ADDITION, GARAGE - 2260SF, REC RM 140SF

RESIDENTIAL PLAN CORRECTION SHEET

ADDENDUM TO PERMIT NO. 98041
Owner Marv Drummend
Contractor SELF
Location 1033 Woodlawn Ave

WALL SECTION @ SLAB ON GRADE

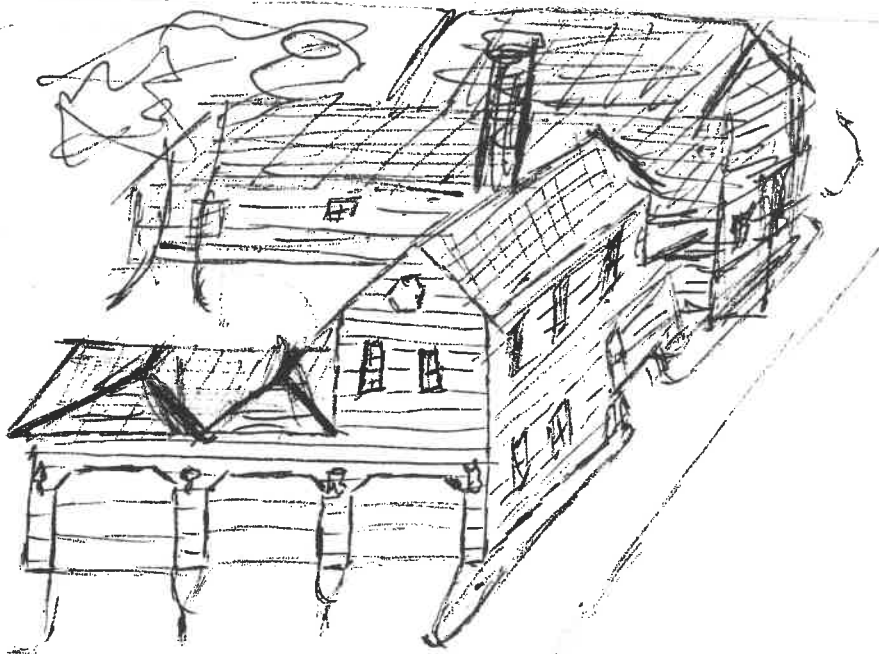
- Show size of wood girder in _____
- Provide design data for structural member in above garage + rec room
- Floor joists undersized in _____
- Provide double joists under parallel bearing partitions.
- Provide 1" x 4" let in corner bracing, approved sheathing, or equal.
- Show size of headers for openings over 4' wide _____

Additional corrections/comments: 2x10 floor joists for Rec room. treated
